Rezoning Transportation Analysis

Petition Number: 2020-111

General Location Identifier: 14117104.

Current Zoning	(R-17MF, 1.61 Acres)			from Planning
Proposed Zoning	Day Care Center	6,237 SF	300	Site Plan: 10-12-20

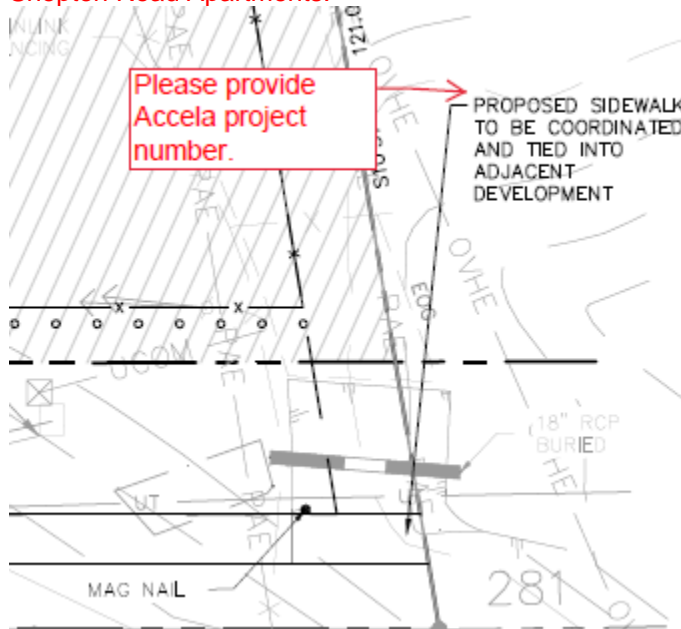
- a. **Dixie River Road:** Update location of curb and gutter 38 feet from center line to back of curb.

Label and dimension curb and gutter from the center line for each road.
